Service Bulletin No: 30-007
Modification No: EC-24-0351

Ref No: 258
ATA Chapter: 30

**ICE AND RAIN PROTECTION - WINDOWS, WINDSHIELDS AND DOORS
MODIFICATION TO REPLACE THE LH WINDSHIELD HEATING SOLID STATE RELAY**

MSN 501 thru MSN 590 - Replace the LH Solid State Relay
Figure 2 (Sheet 1 of 5)

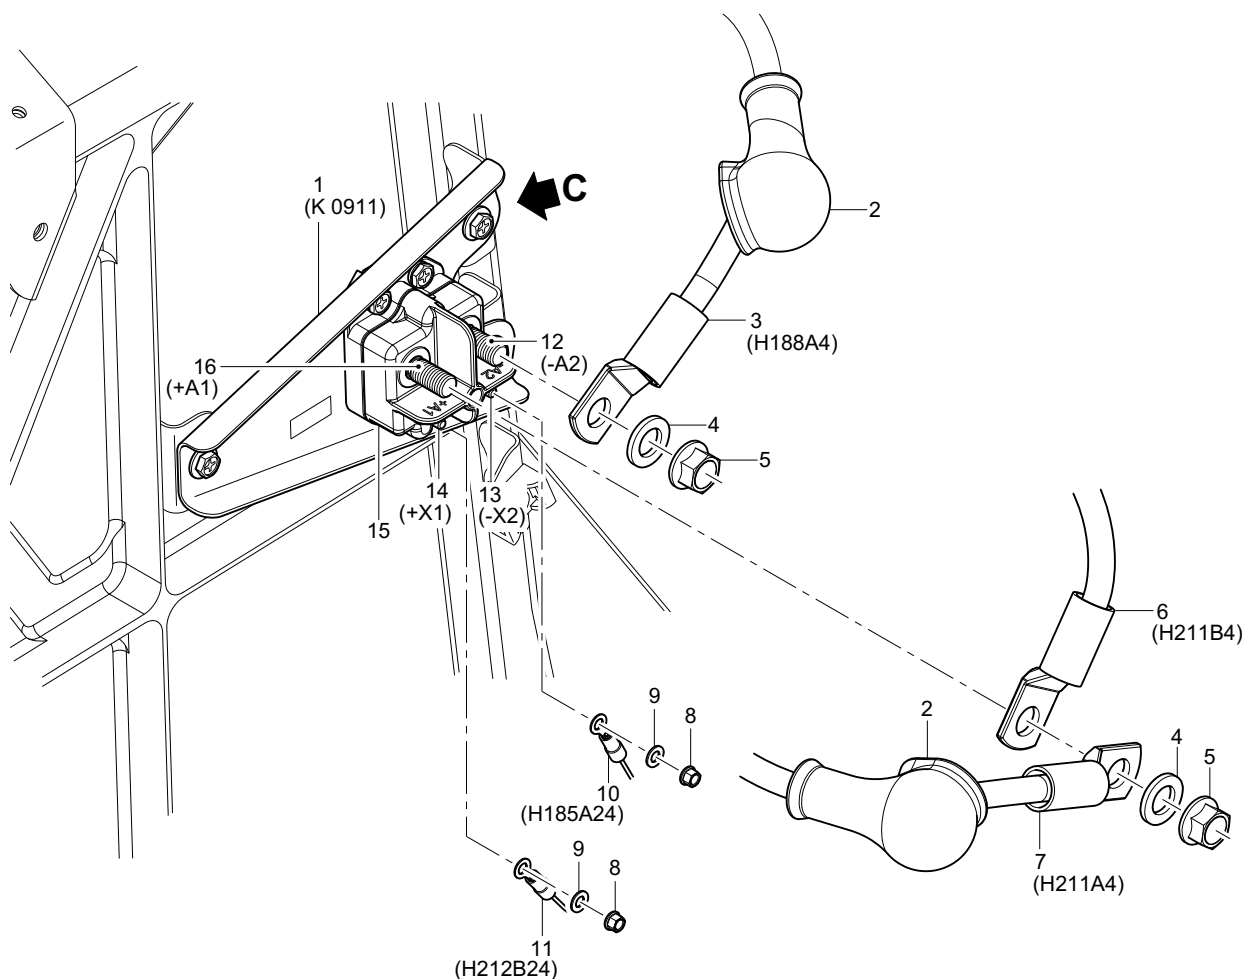
C. Modification - MSN 501 thru MSN 590
Refer to Figure 2

MSN 501 thru MSN 590 - Replace the LH Solid State Relay
Figure 2 (Sheet 2 of 5)

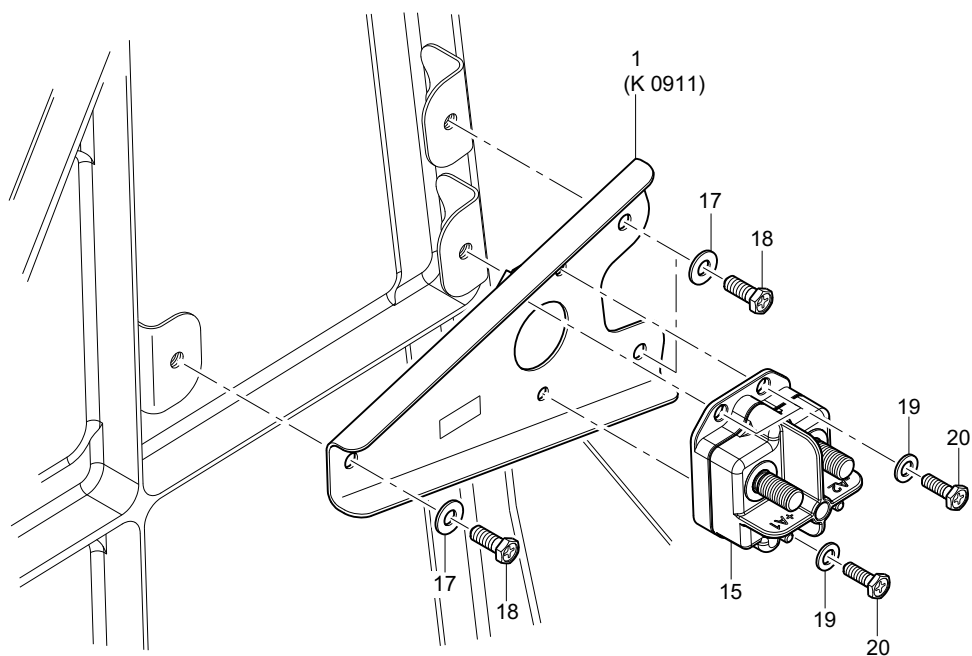
- (1) Remove the LH Solid State Relay (SSR) (15):
Refer to Figure 2 (Sheet 2 and 3)
 - (a) Remove (and keep) the nut (8) and the washer (9) from terminal +X1 (14) on the SSR (15).

- (b) Remove the terminal lug of electrical wire H212B24 (11) from terminal +X1 (14).
 - (c) Remove (and keep) the nut (8) and the washer (9) from terminal -X2 (13) on the SSR (15).

- (d) Remove the terminal lug of electrical wire H185A24 (10) from terminal -X2 (13).
 - (e) Cut and remove the cable ties that hold the two protective caps (2) in position on terminal +A1 (16) and -A2 (12) on the contactor panel K 0911 (1).

MSN 501 thru MSN 590 - Replace the LH Solid State Relay
Figure 2 (Sheet 3 of 5)

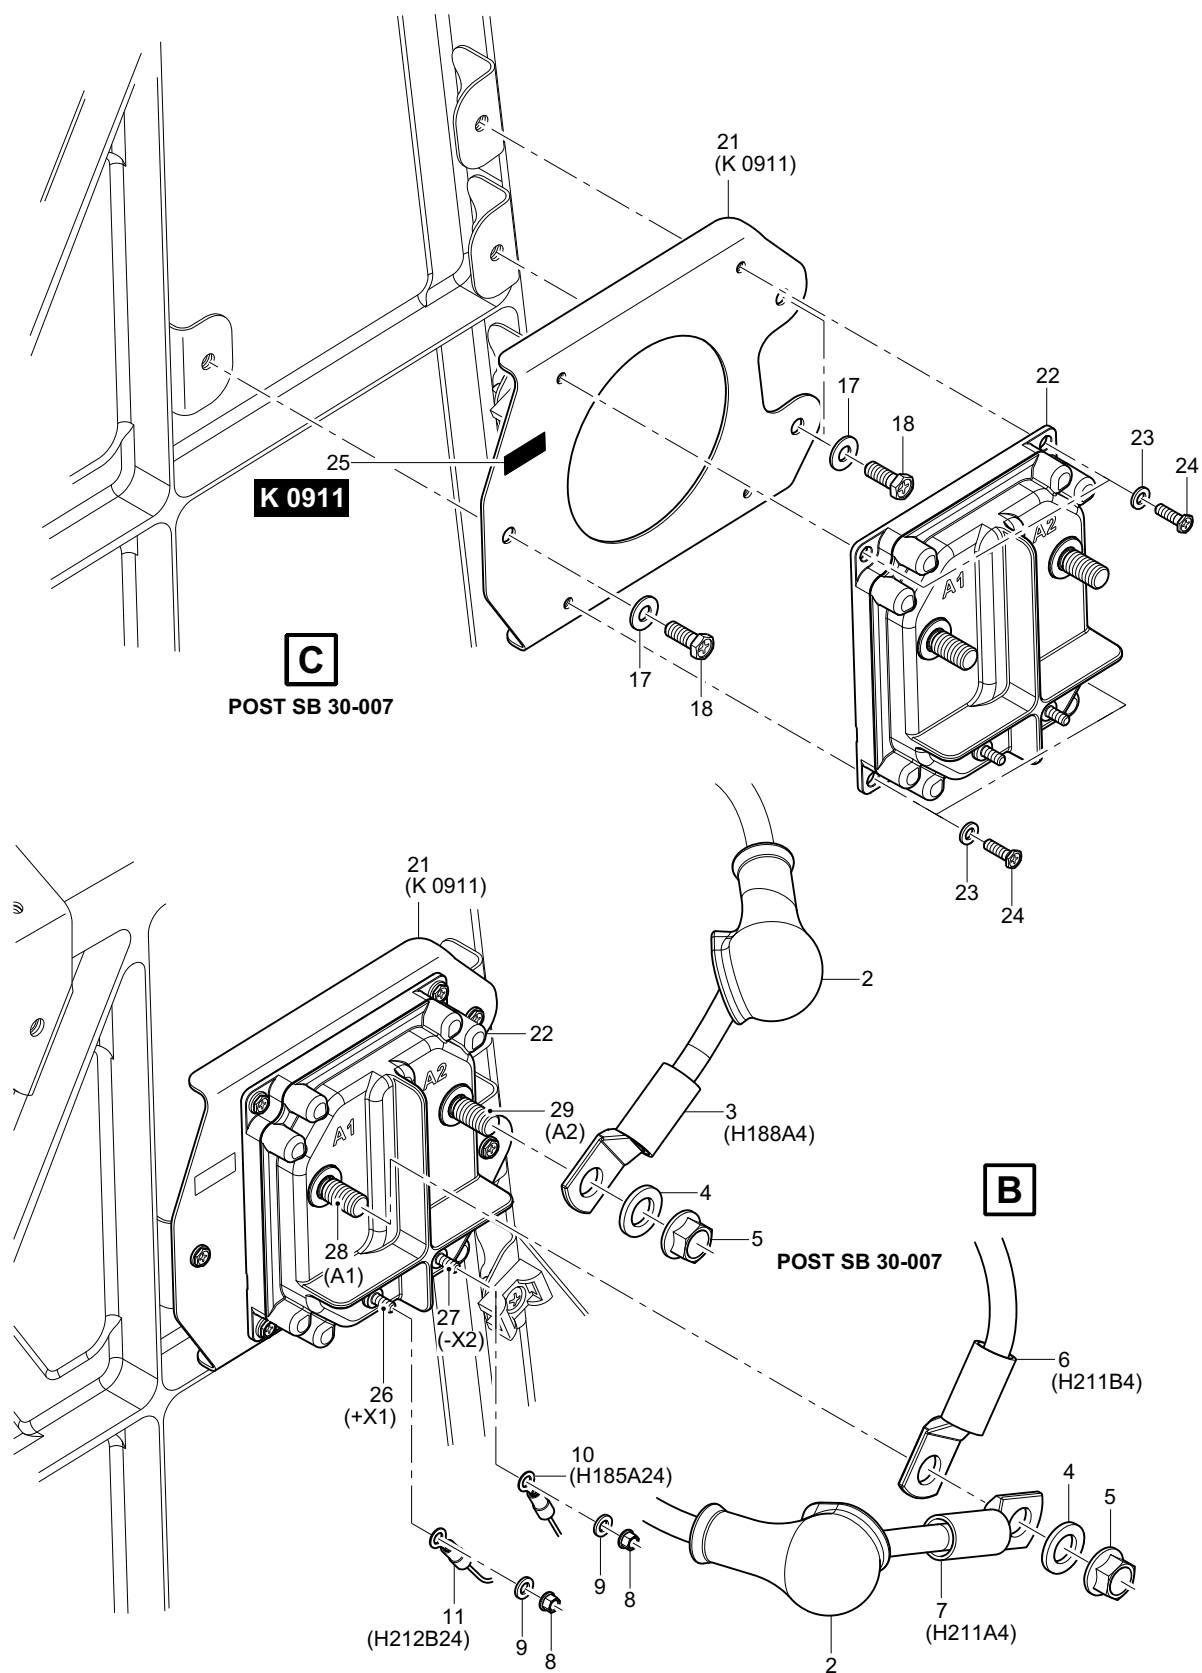
- (k) Cut and remove any necessary cable ties that hold cables/wires in position on the contactor panel K 0911 (1).
 - (l) Remove (and keep) the three screws (18) and the three washers (17) that attach the contactor panel K 0911 (1) to the structure.

- (m) Remove the contactor panel K 0911 (1) (together with the SSR (15)) from the structure.
 - (n) Remove the SSR (15) from the contactor panel K 0911 (1):

- 1 Remove the three screws (20), the three washers (19) and the SSR (15) from the contactor panel K 0911 (1).
 - Discard the contactor panel K 0911 (1)

MSN 501 thru MSN 590 - Replace the LH Solid State Relay
Figure 2 (Sheet 4 of 5)

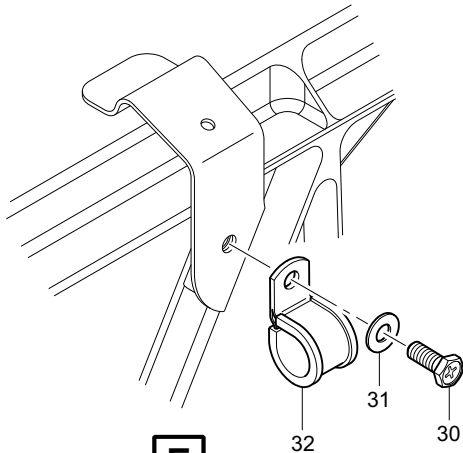
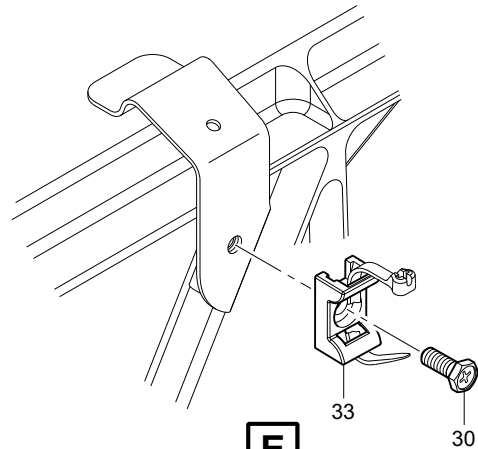
- (o) Remove the clamp (32):
Refer to Figure 2 (Sheet 5, View E (Pre SB))
- 1 Remove the one screw (30) and washer (31) that attaches clamp (32) to the structure near the SSR (15) installation position:

- (2) Install the new LH SSR (22):
Refer to Figure 2 (Sheet 4 and 5)
- (a) Clean the mating surfaces for electrical bonding on the:
- Structure
 - New contactor panel K 0911 (21) (P/N 524.60.24.144)

- 1 Clean the area where the new placard K 0911 (25) (P/N 511.35.24.941) is to be installed with absorbent paper (Material No. P02-031) made moist with isopropyl alcohol (Material No. P01-011).
Refer to Figure 2 (Sheet 4, View C).
- 2 Let the area dry.
- 3 Remove the backing strip from the new placard K 0911 (25).
- 4 Install the new placard K 0911 (25) in position on the contactor panel K 0911 (21). Make sure that no air bubbles are caught between the placard and the surface.

- (l) Install the saddle (33):
Refer to Figure 2 (Sheet 5, View E)

MSN 501 thru MSN 590 - Replace the LH Solid State Relay
Figure 2 (Sheet 5 of 5)

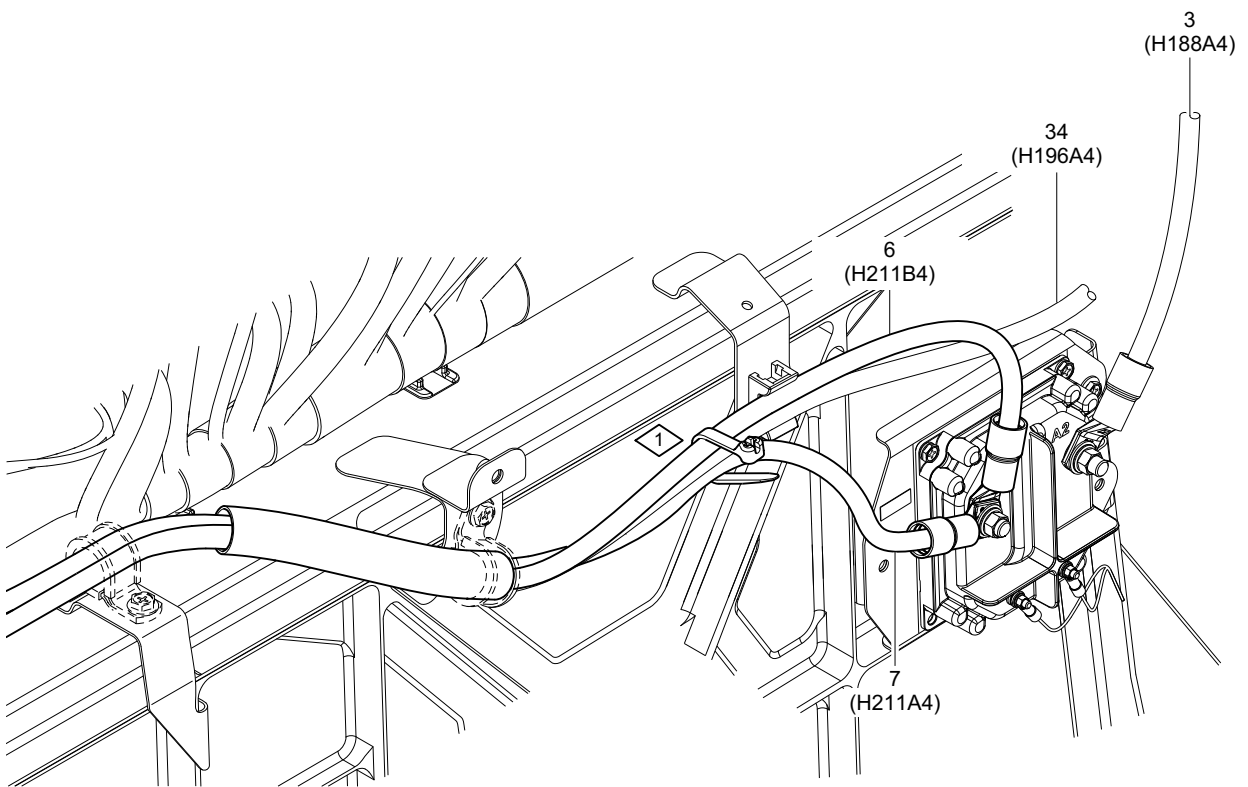
Refer to Figure 2 (Sheet 5, View F).

- (m) Make bends in the feeder cable H211A4 (7), as necessary, so that the terminal lug can be installed on terminal A1 (28) of the LH SSR (22).
Refer to Figure 2 (Sheet 5, View F).
- (n) Use an applicable cable tie (Material No. P09-140) to attach the feeder cable H211A4 (7) to the other cable(s) H211B4 (6) and H196A4 (34). Refer to Figure 2 (Sheet 5, View F and Flag Note 1).
